50-280

INFORMATION CONCERNING HIGH DENSITY SPENT FUEL
STORAGE RACKS....INS RESPONSE TO NRC QUESTIONS
SUBMITTED BY LTR DTD 8/25/77.....

FIGURE 4-1

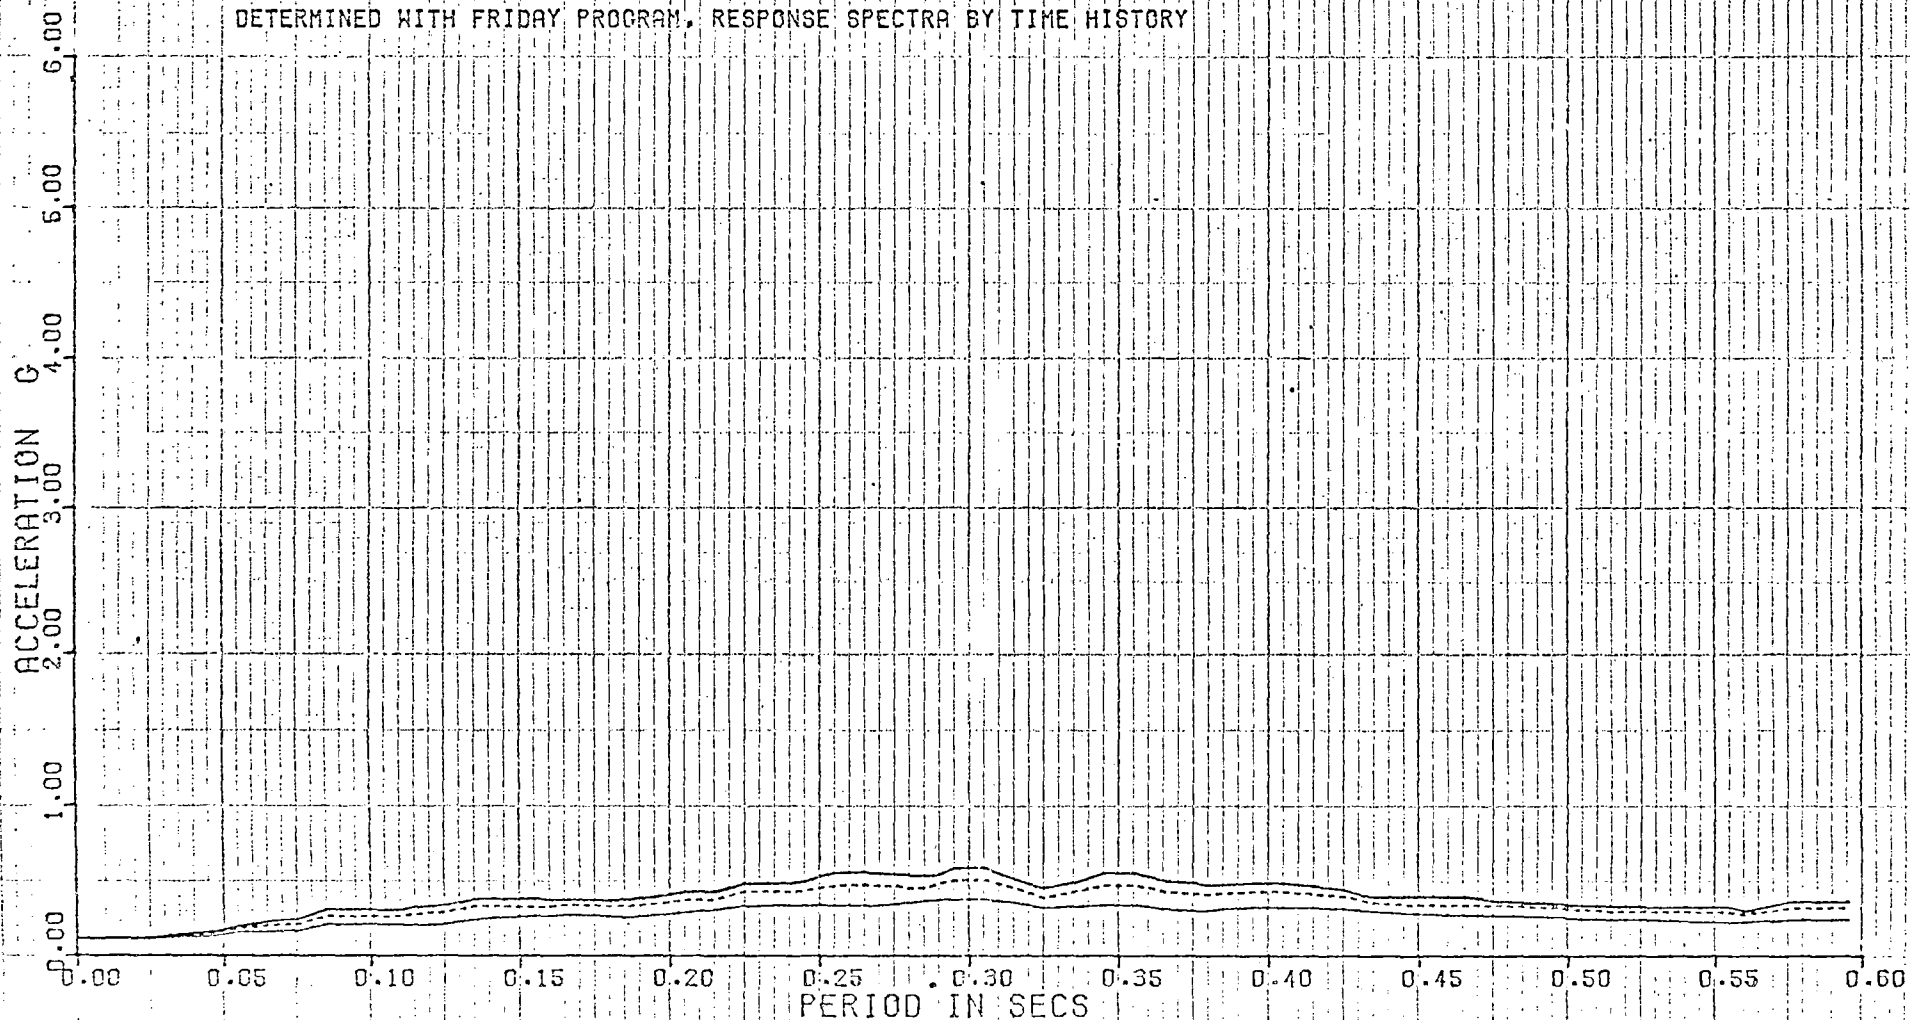
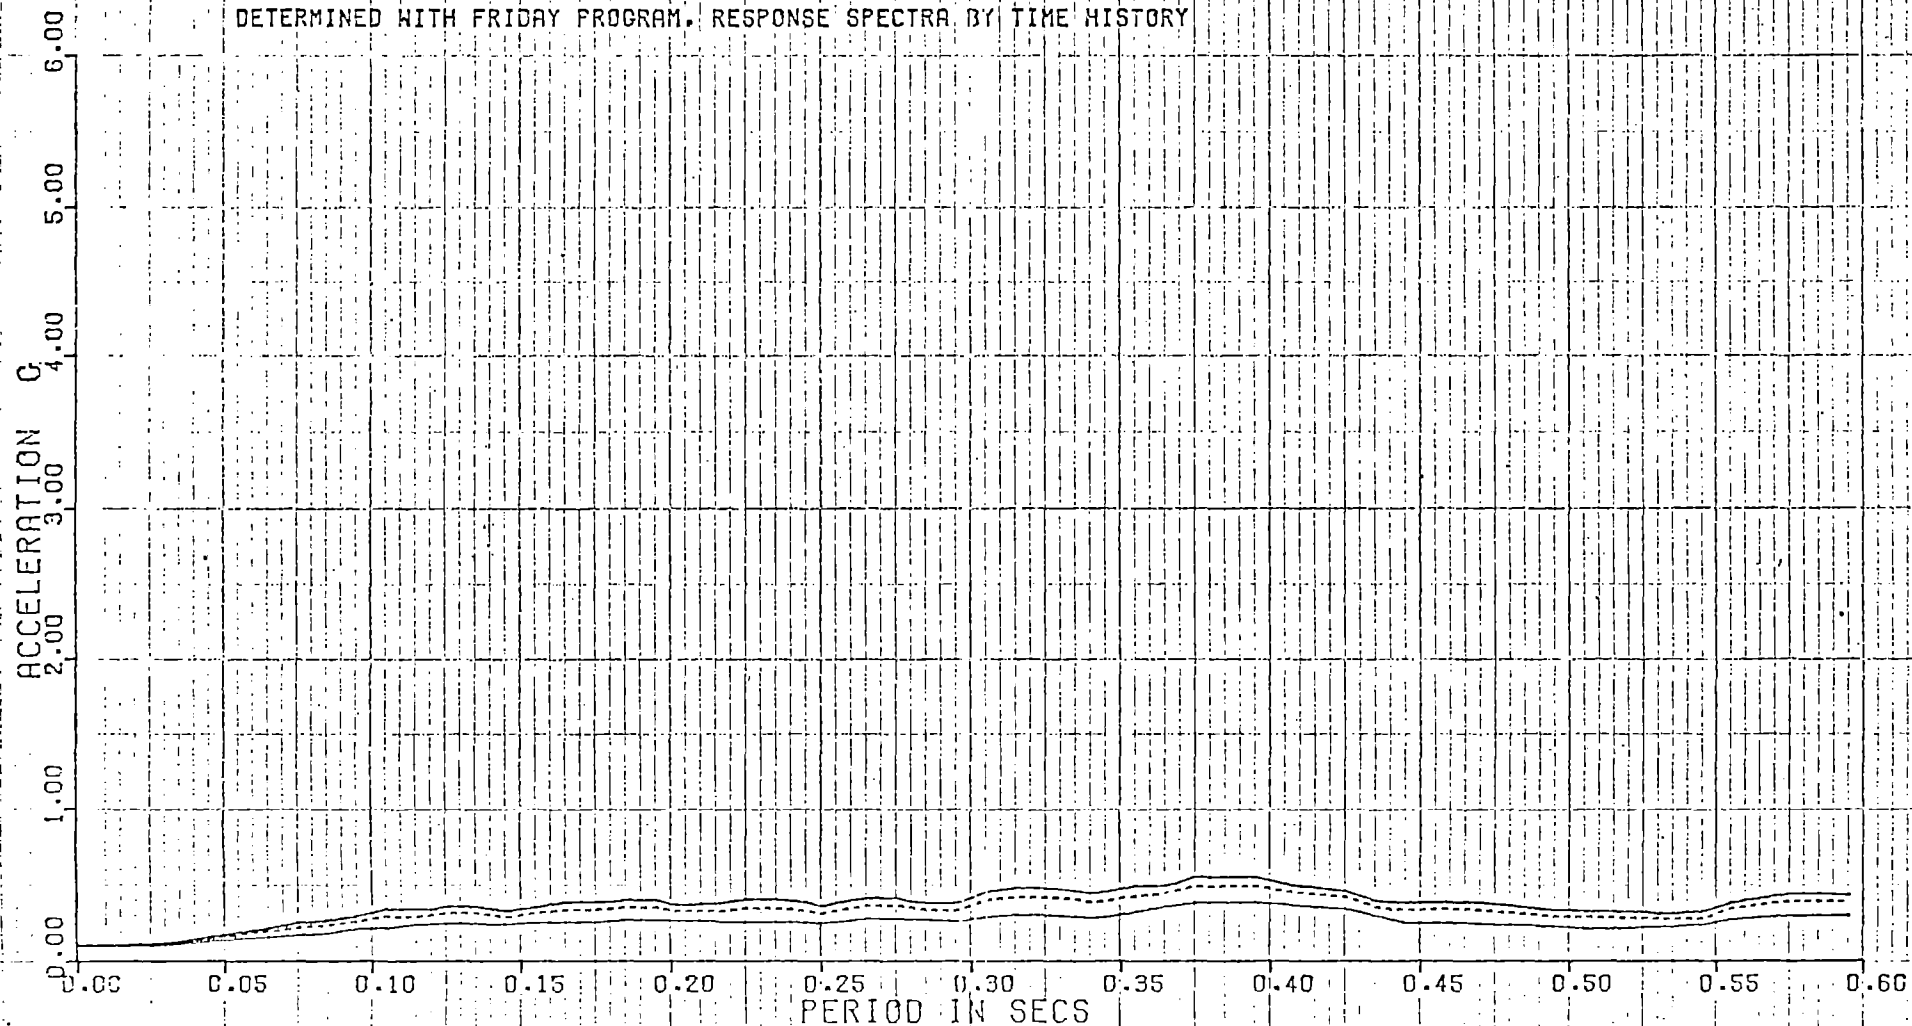
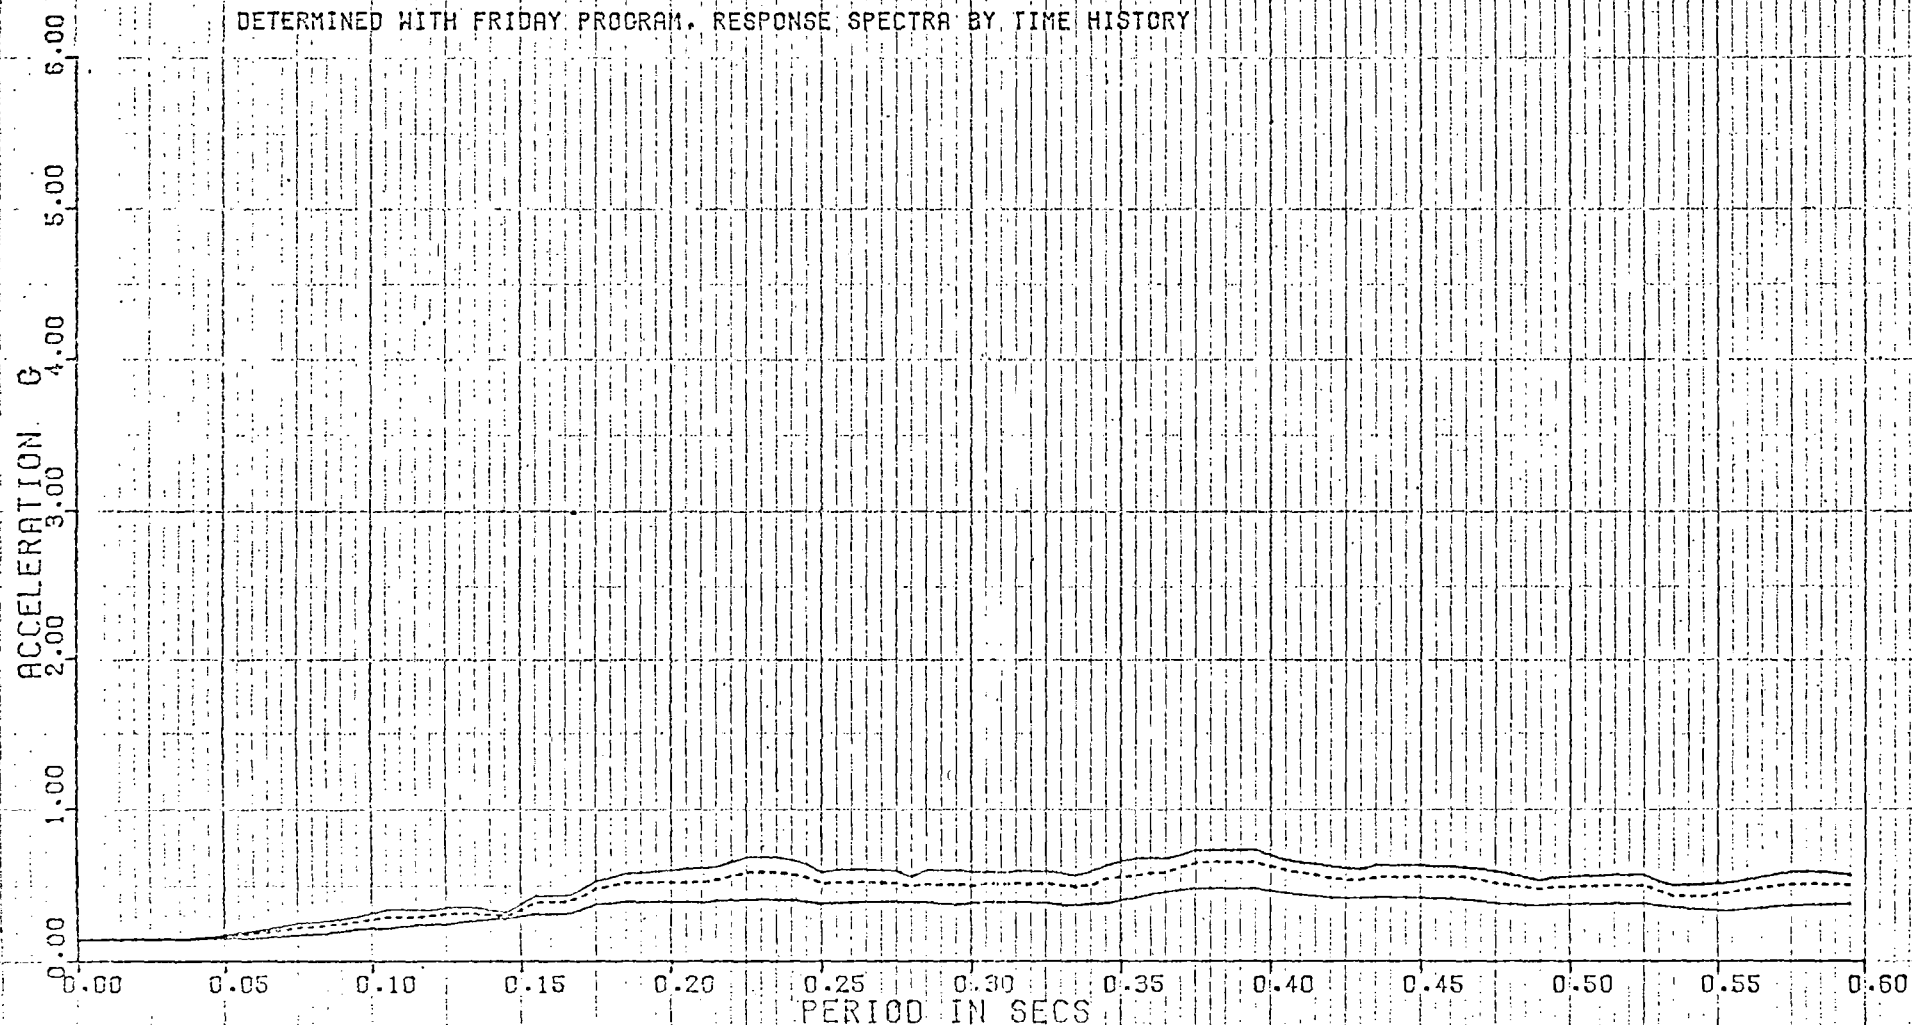
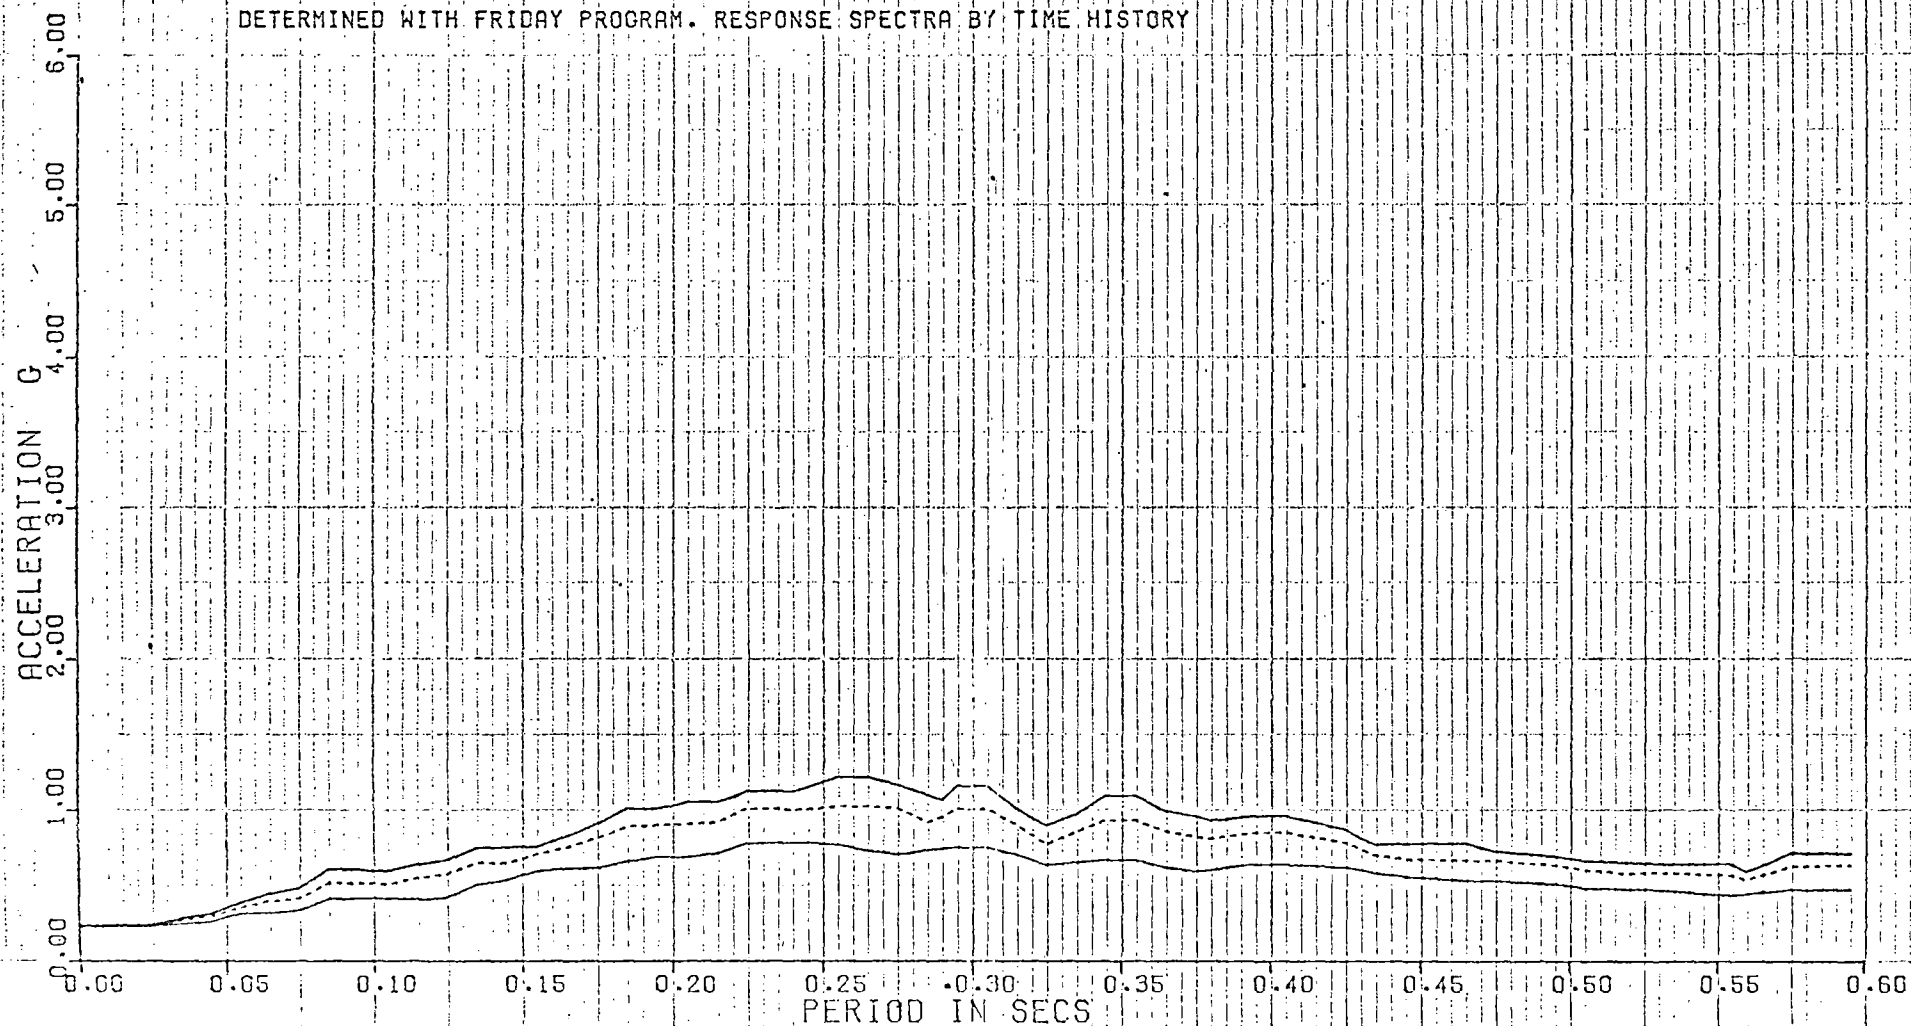
Question 4: In Section 6.3.1.1 it should be clearly stated (SIC) which ground response spectra and amplified floor response spectra were used for this modification indicating the appropriate SSE and OBE values. Also indicate how the allowable stress values for stainless steel at various design temperature were obtained.

Response: The amplified response spectra used in the design of the spent fuel racks are shown in Figures 4-1 through 4-6. The ground acceleration values in section 2.5 of the Surry 1 and 2 FSAR were used to generate these curves. A dynamic model representing the fuel building structure and the subgrade was prepared. This model was used to calculate amplified response spectra (ARS) due to the specified earthquake. ARS were generated for both the Safe Shutdown Earthquake (SSE) and the Operational Basis Earthquake (1/2 SSE) at the mat surface, the top of the concrete structure, and the roof of the steel superstructure. The response spectra of the design earthquakes used are consistent with the requirements set forth by NRC Regulatory Guide 1.60, and the damping levels are from NRC Regulatory Guide 1.61.

The dynamic analysis was performed for a range of subgrade properties to account for uncertainties in soil parameters. The ARS provided are the result of enveloping the response spectra obtained from these analyses. They also include the design ground response spectrum.
